**ALLEGHENY COUNTY SANITARY AUTHORITY**

**CONTRACT NO. 1735 G, E, H, P**

**ALCOSAN PARKING GARAGE**

**ADDENDUM NO. 2**

**2 NORTH FOUNDATION WALL ELEVATION**  
 S-21 SCALE: 1/8" = 1'-0"

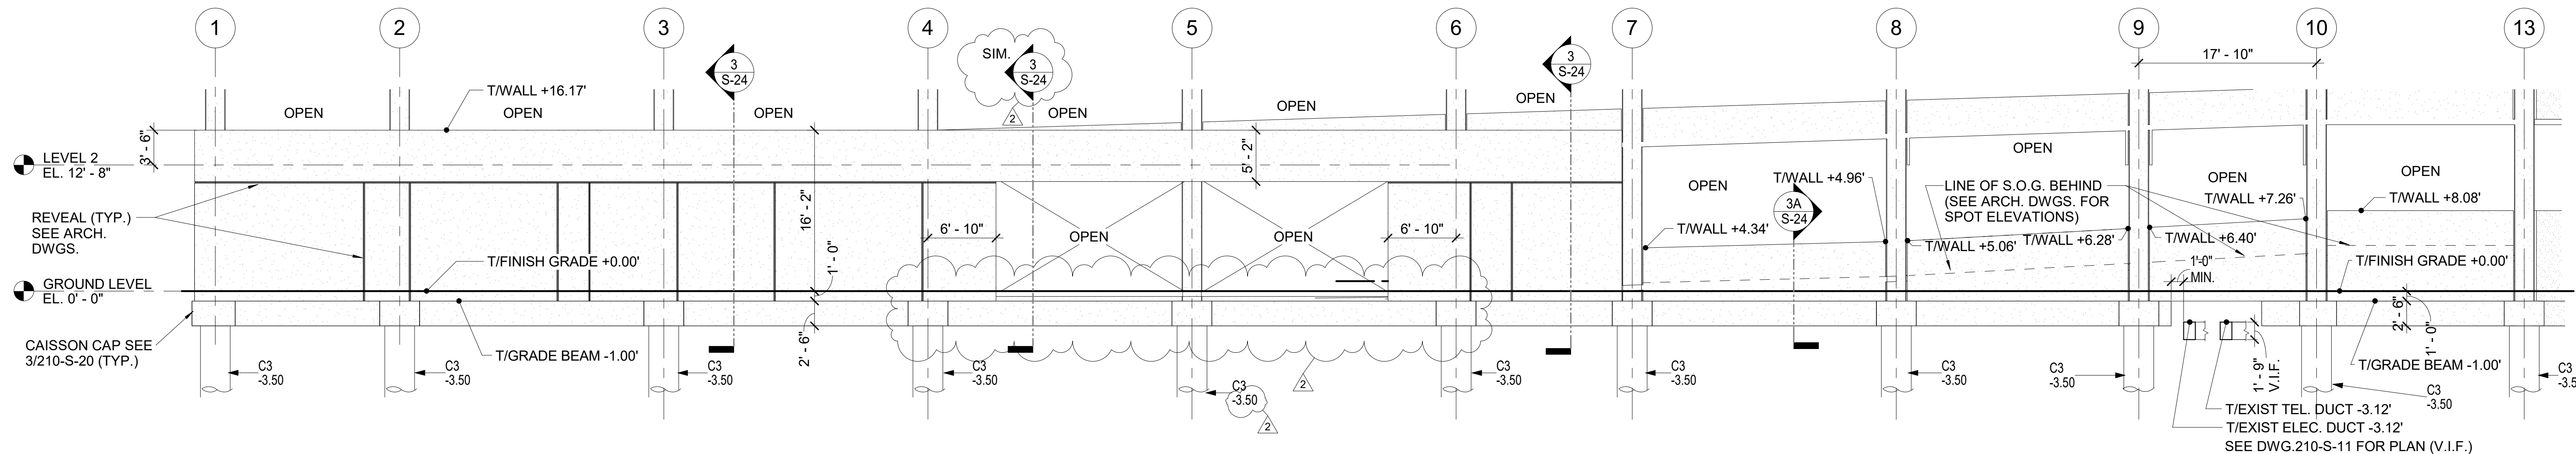
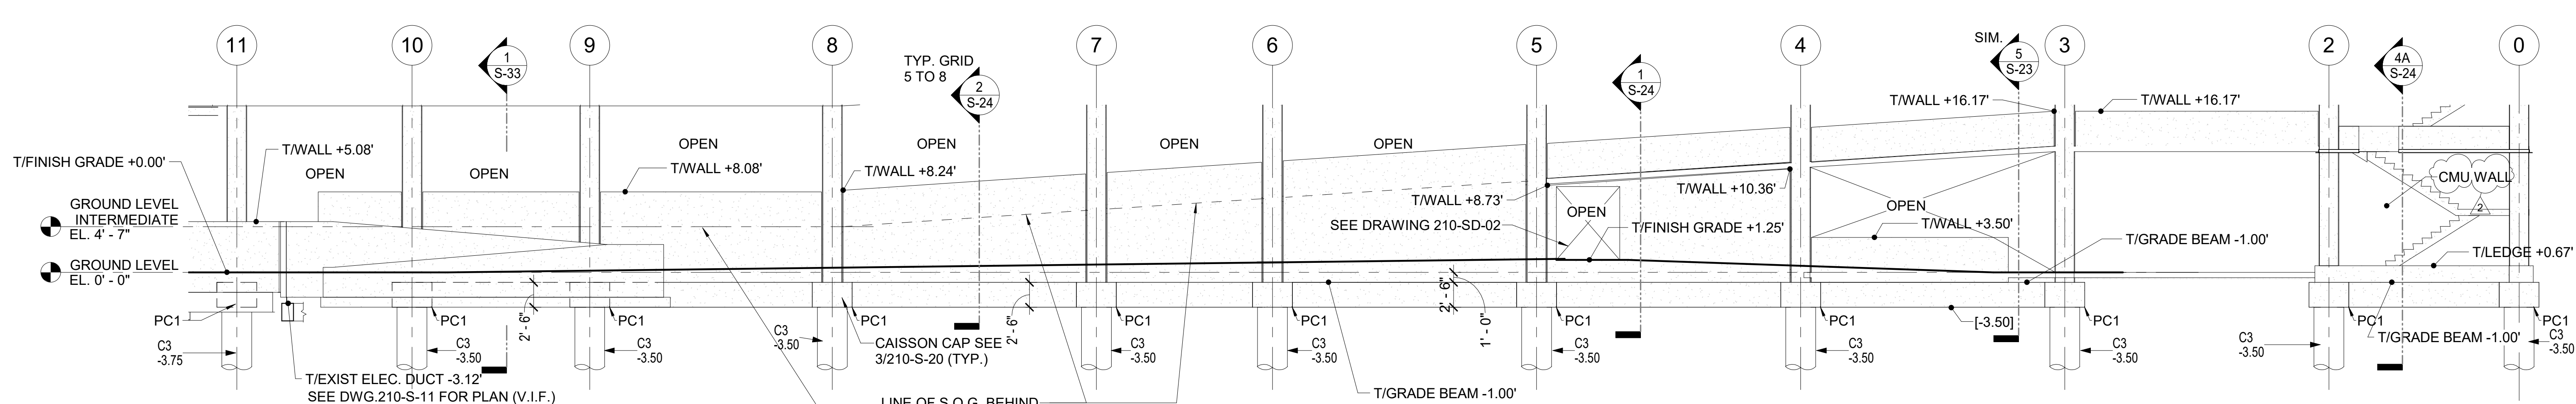
38. Drawing 210-S-21 - Foundation Wall Elevations
  - a. REPLACE with the attached drawing 210-S-21.
  - b. Extended the grade beams between lines 4 and 6 in elevation 1.
  - c. Clarified the CMU wall location in elevation 3.

1 STAIR 1/ELEVATOR - GROUND LEVEL PLAN  
S-31 SCALE: 1/4" = 1'-0"

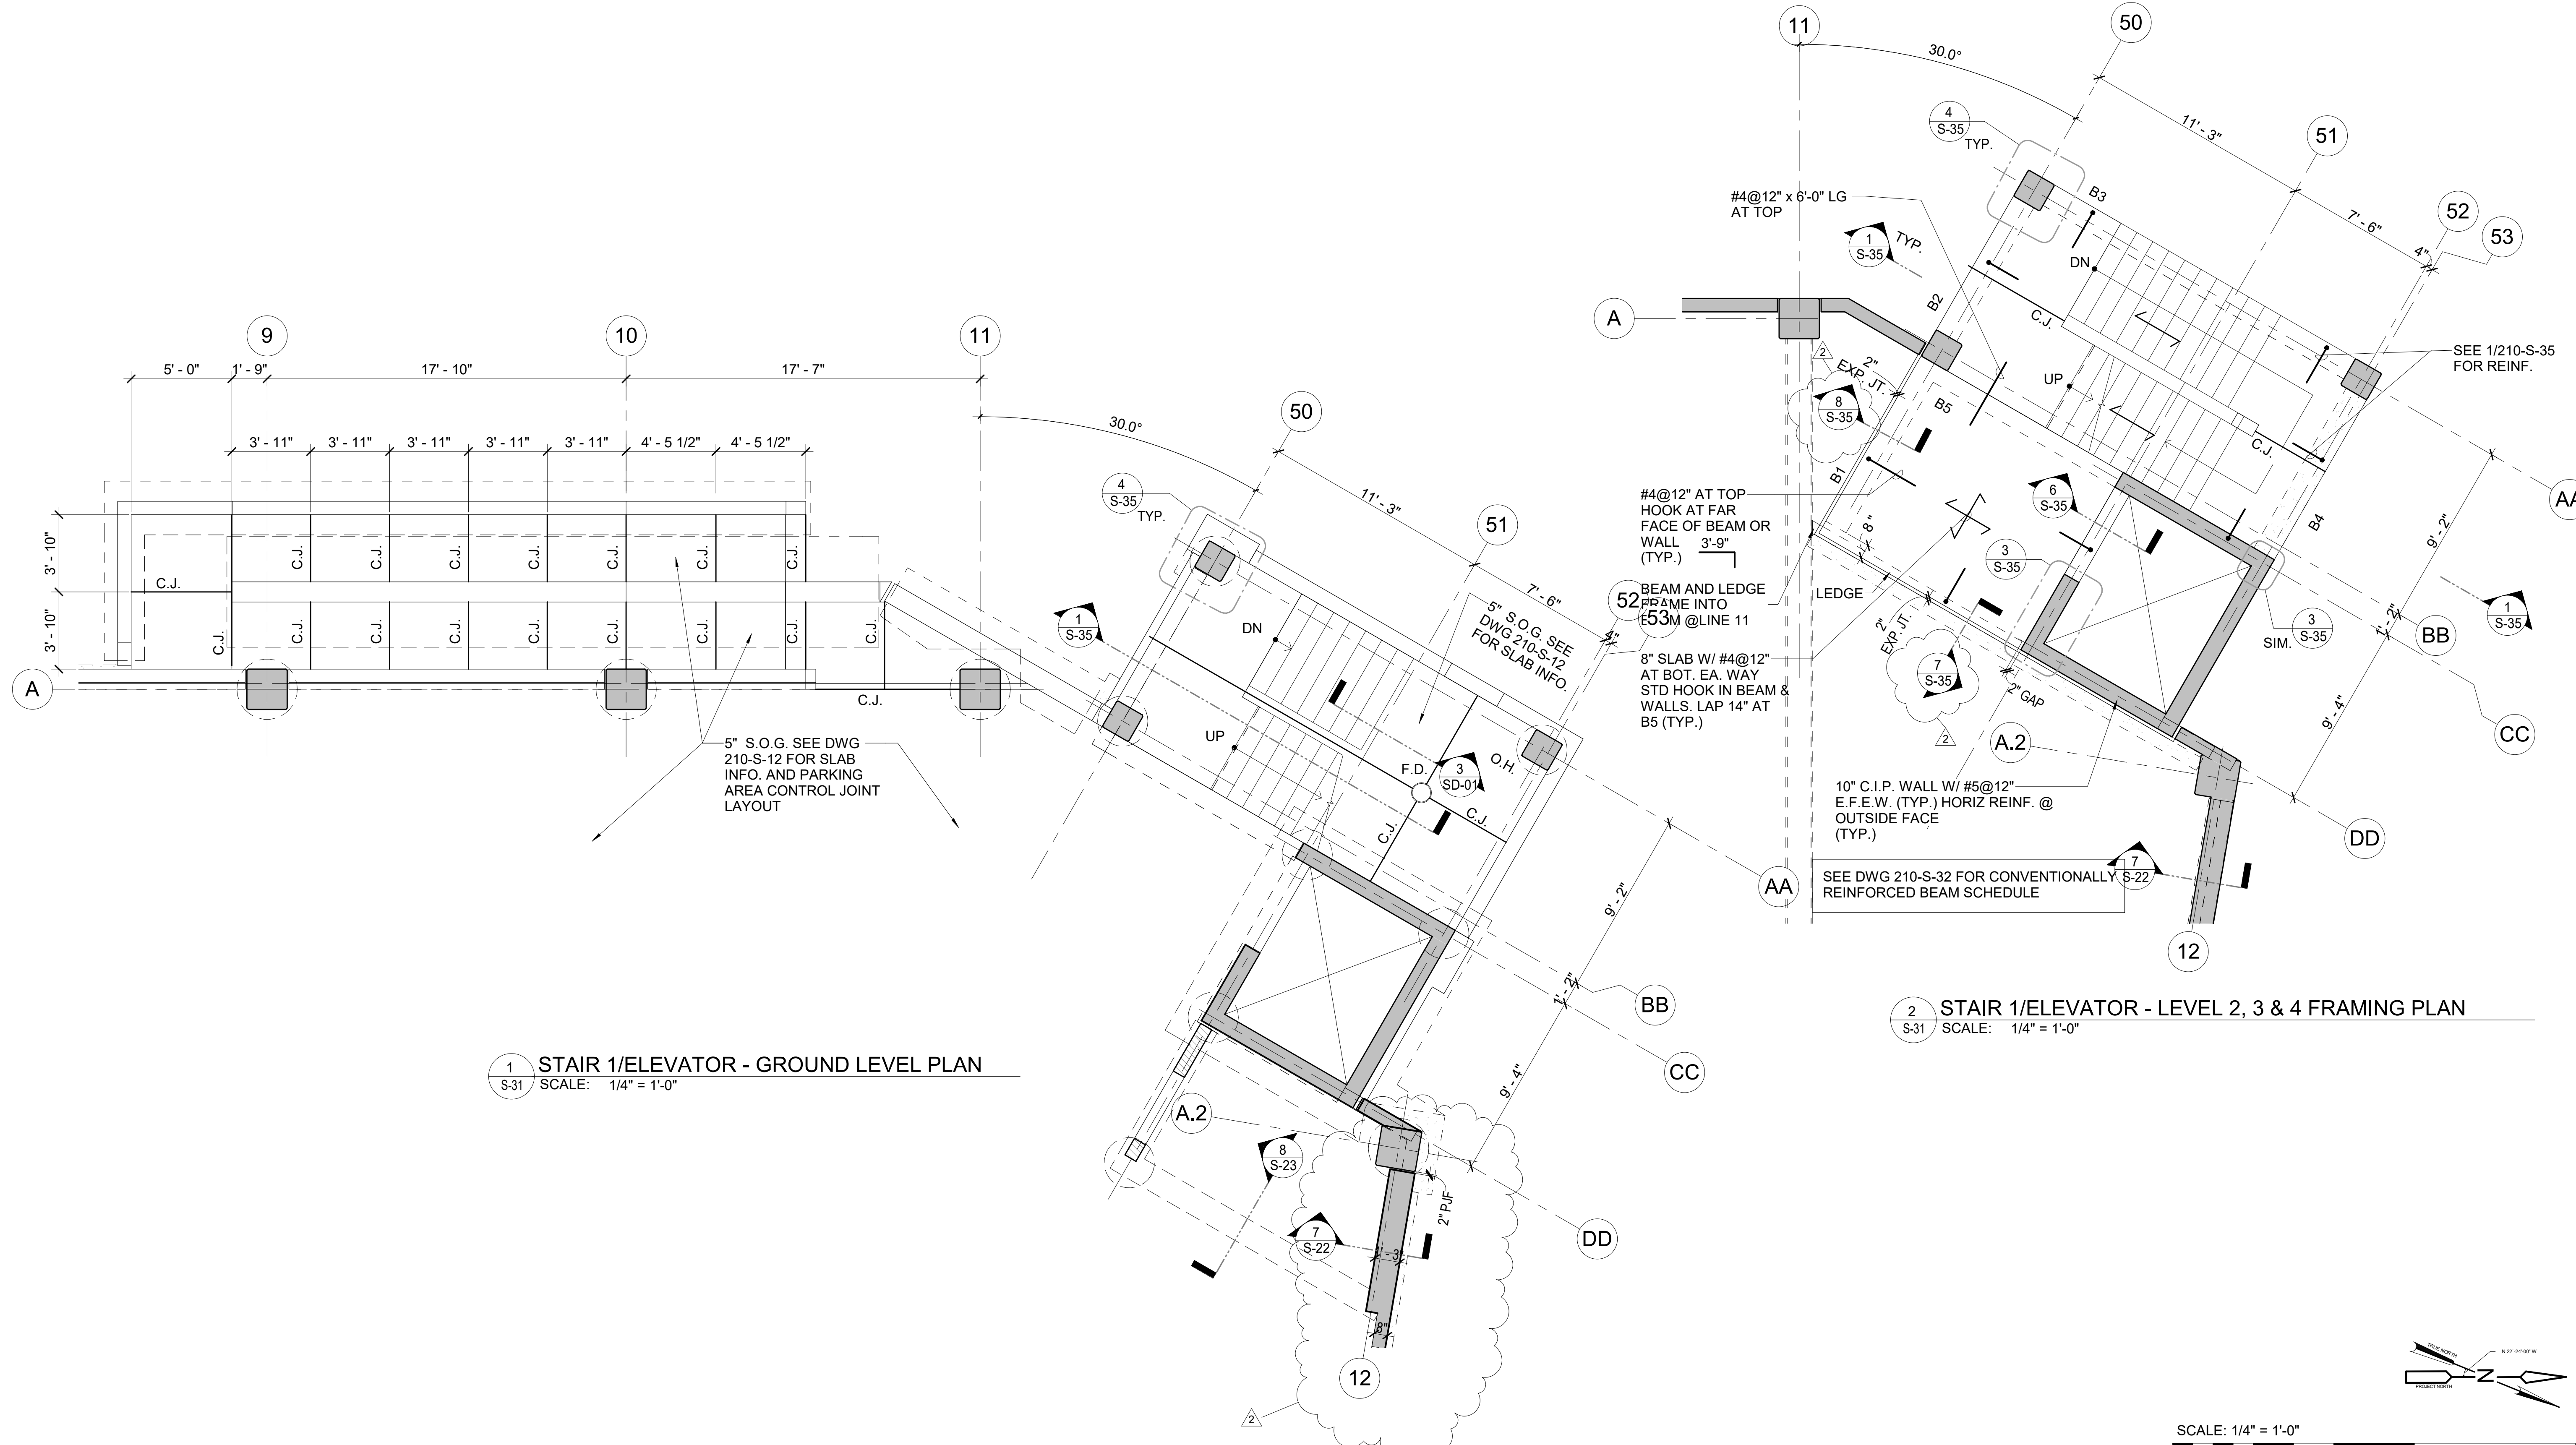
42. Drawing 210-S-31 - Stair 1/Elevator – Enlarged Plans
  - a. REPLACE with the attached drawing 210-S-31.
  - b. Location of section references 7 and 8/210-S-31 have been clarified.

ALLEGHENY COUNTY SANITARY AUTHORITY  
WASTEWATER TREATMENT PLANT  
ALCOSAN PARKING GARAGE  
210-C-32  
PHASE I CONSTRUCTION DETAILS

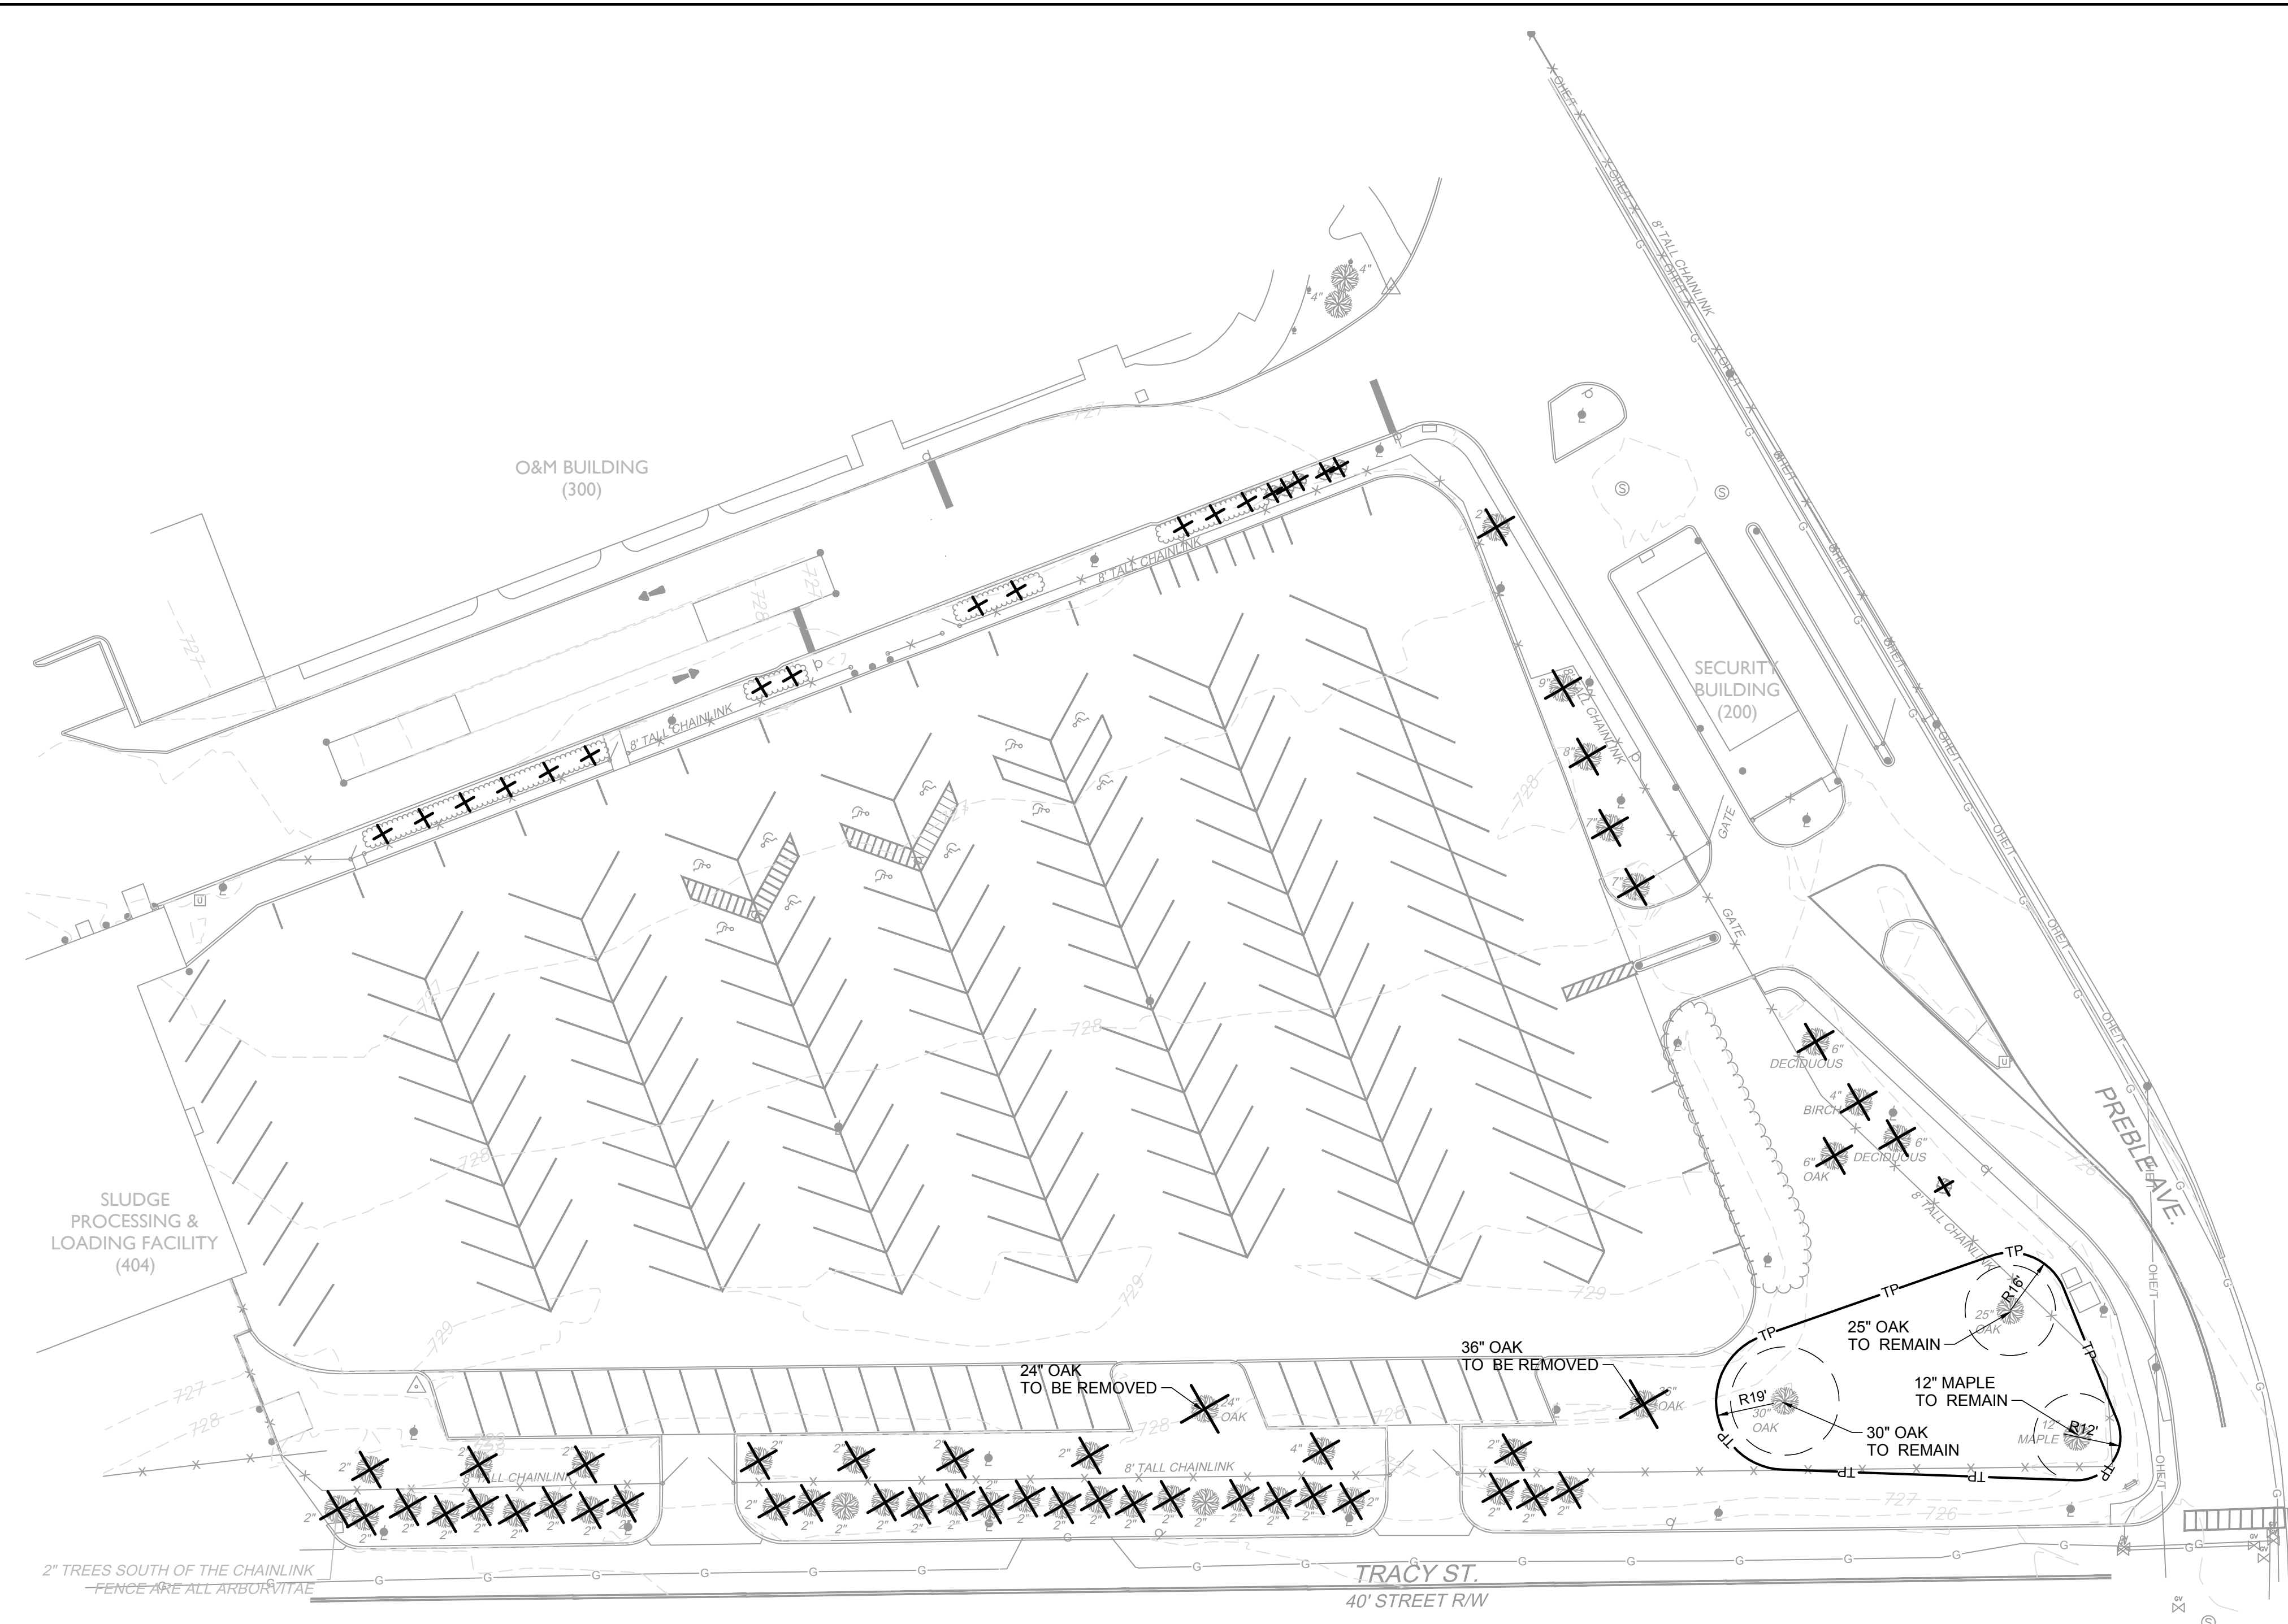
4. Drawing 210-C-32 Phase 1 Construction Details
  - a. DELETE this drawing and REPLACE with the attached drawing 210-C-32.
  - b. Pipe trench temporary gravel pavement replacement detail added.
  - c. Pipe trench landscape/lawn replacement detail added.
  - d. Concrete Pavement Detail added
